DART CNG Front Cap rubber

Issue: Rubber seal coming loose from front cap

Engineering Documentation: ECN N13-34151

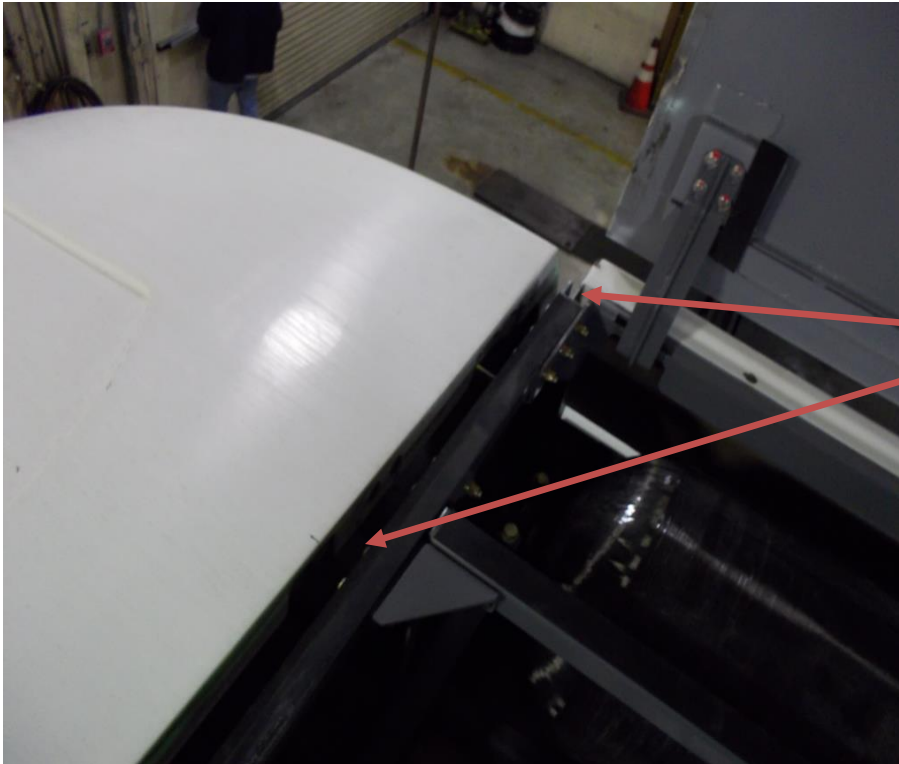
Reason/ cause: Metal in bulb seal is not encased with rubber

Solution: Replace with different rubber seal

Necessary parts: Bulb seal Part# 900-1511-001 15 foot per bus
